JOINT REGIONAL PLANNING PANEL (Hunter Central Coast Region)

JRPP No	2010HCC048
DA Number	39936/2010
Local Government Area	Gosford
Proposed Development	MIXED USE DEVELOPMENT - OFFICES/BUSINESS & RESIDENTIAL UNITS (77) (JRPP) ON LOT: 11 DP: 1046189, 7 WATT STREET GOSFORD
Street Address	7 Watt Street, Gosford
Applicant/Owner	Tilrox Developments Pty Ltd

EXECUTIVE SUMMARY

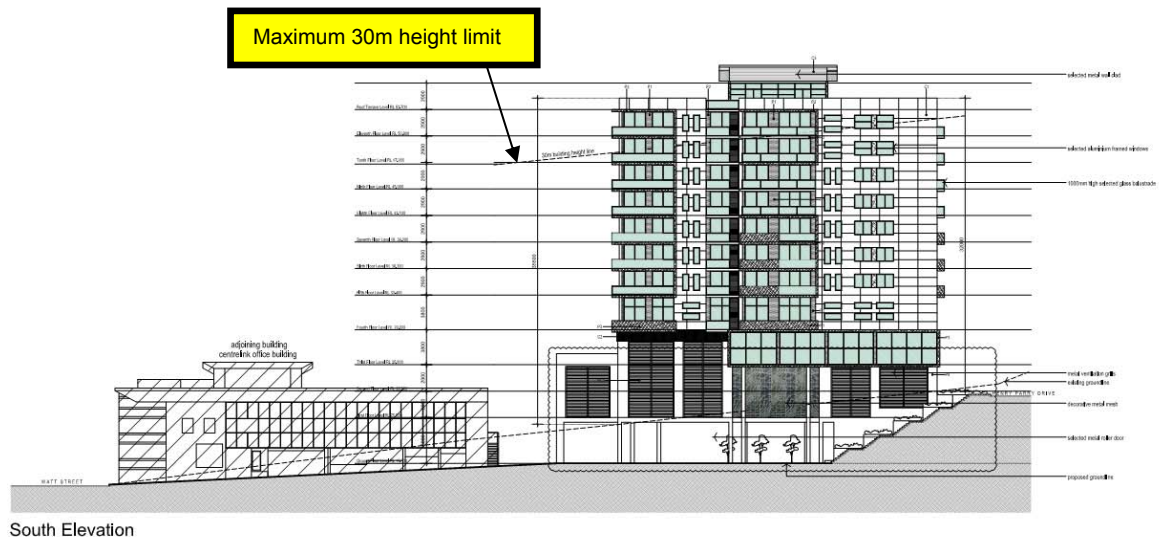
The plans indicate the extent to which the proposed building is higher than 30m, with the 30m height line indicated on the south elevation and Section BB below:

As shown on the plans, the height is exceeded at the lowest south-western and south eastern corners of the building where maximum height of 35.5m (variation of 18%) and 32m (7%) respectively is calculated. The area of the building which is non-compliant with the height control is most evident on the south and west elevations and represents one storey or approximately 75% of the top floor residential level to varying extents. Excluding the roof top stair structure, the building has a parapet height at RL 54.9 (at NGL 19.4m) with a maximum height of 35.5m at the SW corner of the building.

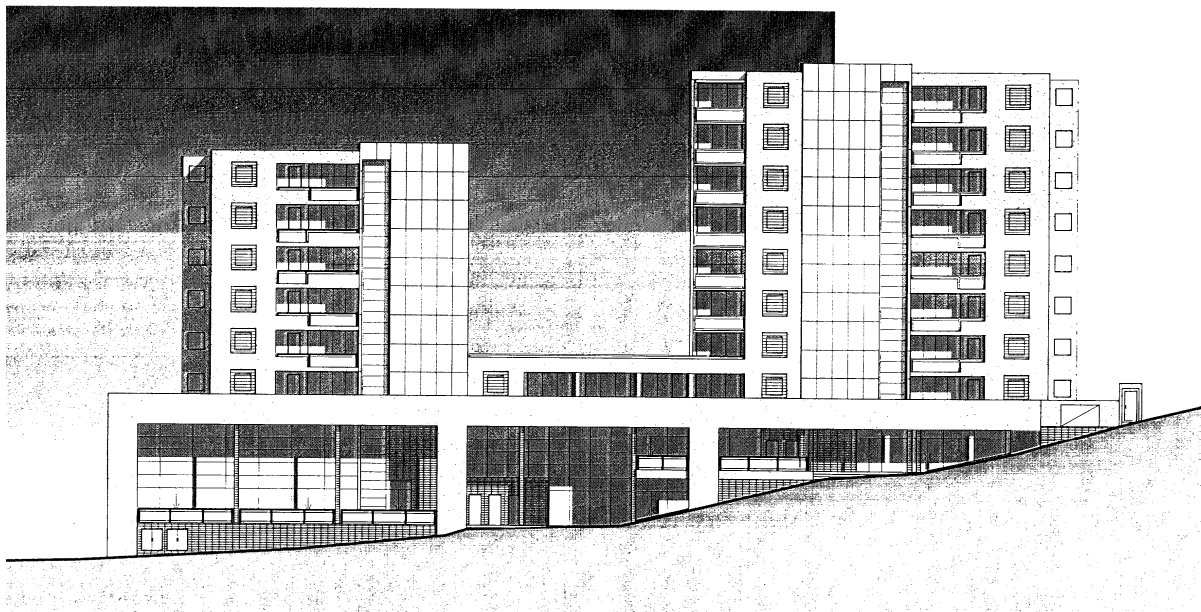
The building height map (GCC LEP) indicates a maximum building height of 30 metres generally for land within the commercial core of Gosford City centre, which has frontage to Henry Parry Drive and is located at the base of Rumbalara Reserve, which forms a natural vegetated backdrop to the city centre. The formulation of the height controls under the LEP has regard to appropriate heights for the natural environmental setting. Taller building forms may generally be accommodated at the base or lower slopes of vegetated hillsides as they are visually contained by the steep natural vegetated backdrop, providing view lines of the vegetated backdrop from public domain areas are maintained.

The proposal will not have a visual impact when viewed from open public land (Kibble Park) at ground level or immediate street frontages. The height and bulk of the building only becomes apparent when viewed at a distance, at a higher hillside location or from upper floors of surrounding buildings and the southern end of Henry Parry Drive. Whilst the height of the proposal by itself does not restrict view lines, concern is raised if adequate building separation distances are not maintained which may contribute to a perceived continuous wall or merging

The current proposal is a one storey or more (excluding roof top structure) above the height limit, maintaining a consistent floor level within one tower. The height could be reduced by removing in part or in full residential level no. 11 which contains 11 units, providing greater building setback at the south and west boundaries for topmost levels, or lowering basement car park levels which are largely above ground level. The applicant has not included any changes in the amended plan set to alter the building form thereby reducing the visual bulk and height of the building or increase separation distances to address issues raised by the SEPP 65 panel and Council's Architect. As a result the visual impact of the proposal is considered to be unsatisfactory.

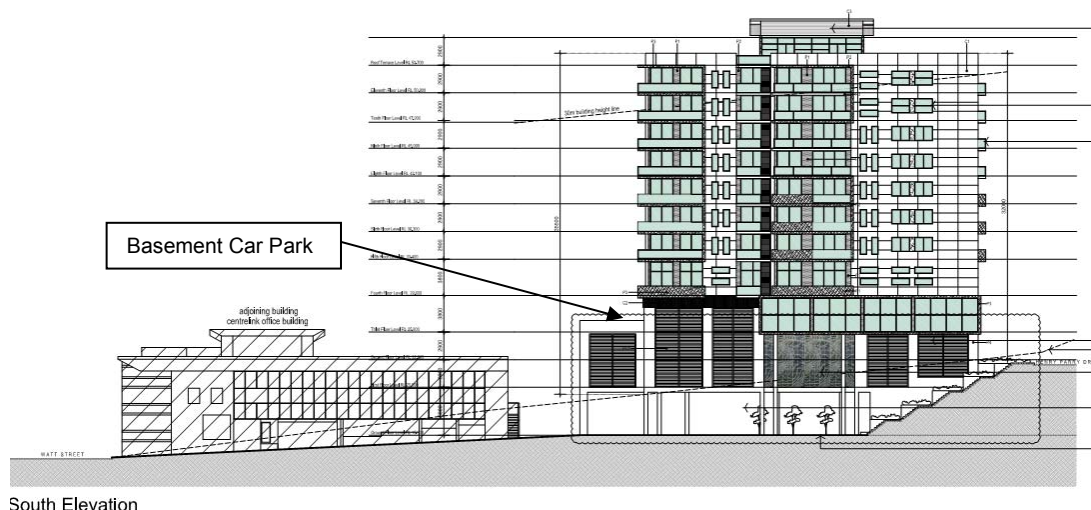
The proposed car parking is partly located above ground level as indicated on the south and west elevations and will be visible from view as it extends above the single storey height of the adjoining development to the south, approaching traffic/pedestrians Henry Parry Drive and will extend above the height of the adjoining Centrelink building to the west which has frontage to Watt Street.

Figure 7: Building Depth and Bulk Controls – Commercial Core GCC DCP

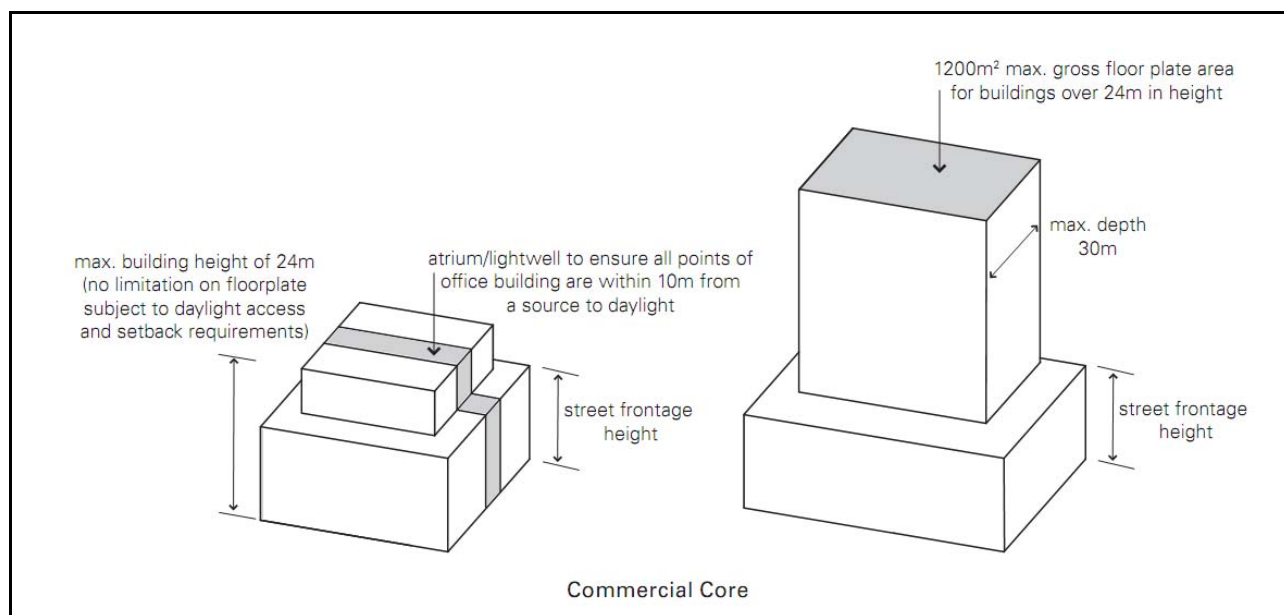
Clause 2.3 of the GCC DCP stipulates a minimum floor plate size of 1200m² for buildings above 24m in height with a maximum building depth of 30m (excluding balconies). Subclause (b) also requires that no building above 24m in height is to have a building dimension in excess of 45m. **(Refer Figure 7: Building depth and bulk controls for commercial core)**

Figure 8: Potential Building Separation Plan (Source: Architex - DA16)

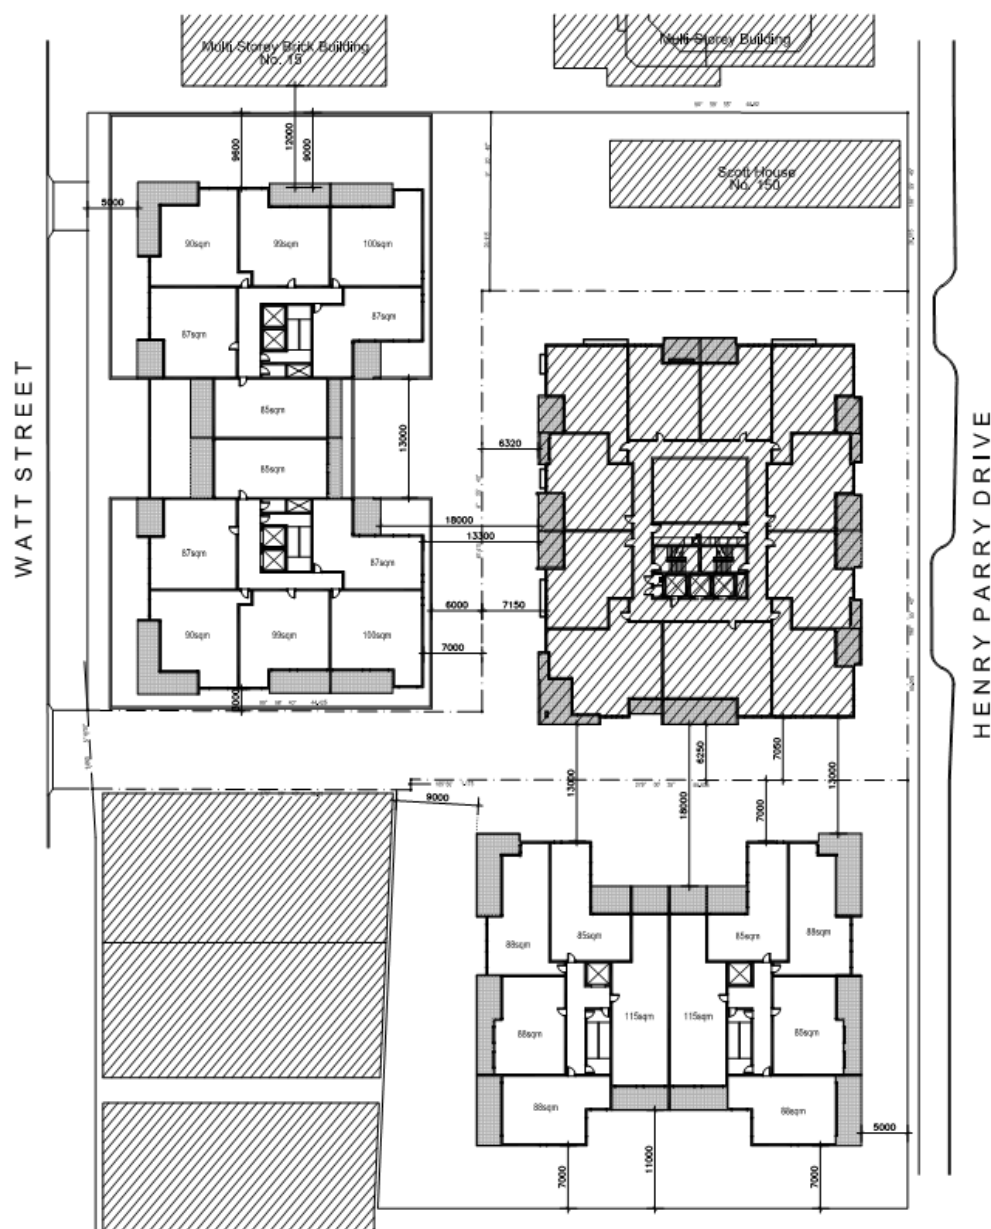
The drawings including possible buildings on adjoining sites clearly show this application relies on increased setbacks on the adjoining sites to achieve the building separation recommended in the RFDC rather than providing the required setbacks on the subject site.

In terms of the potential future development on adjoining sites, we have prepared two (2) additional drawings (DA-16 and DA-17) to illustrate the potential development on the two (2) adjoining properties to the west (Centrelink Building at 9 – 11 Watt Street) and to the south (138-142 Watt Street). (Refer Attachment - Figure 8)

These drawings illustrate the potential for each site based upon a mixed-use development on a commercial podium with a residential tower. The site planning illustrates that the proposed setbacks provided for in the current design will achieve the prescribed separation distances recommended by the RFDC on Page 28 as follows:

Figure 10 Architect's Photo View Montntages (Source: Architex)

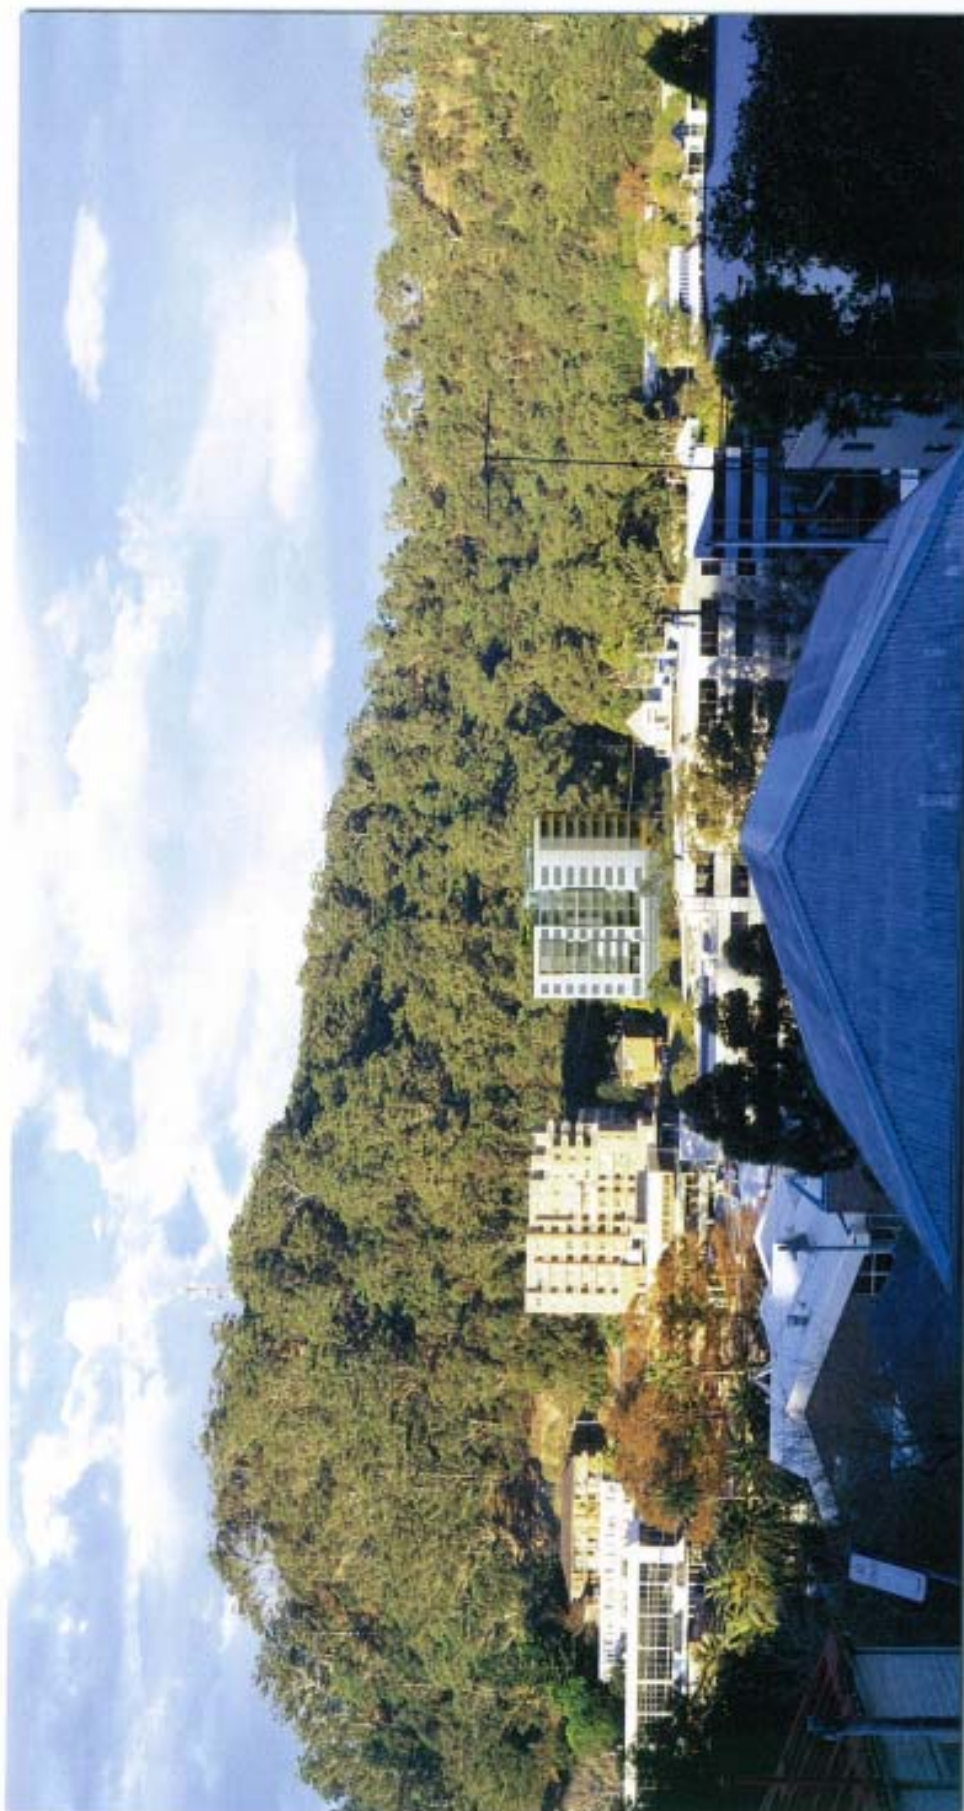
of development along the lower slopes of the reserve when viewed from distant vantage points. The applicant has provided three perspectives (photo montage) with the development superimposed from various mid to distant vantage points. **(Refer Attachment - Figure 10))**
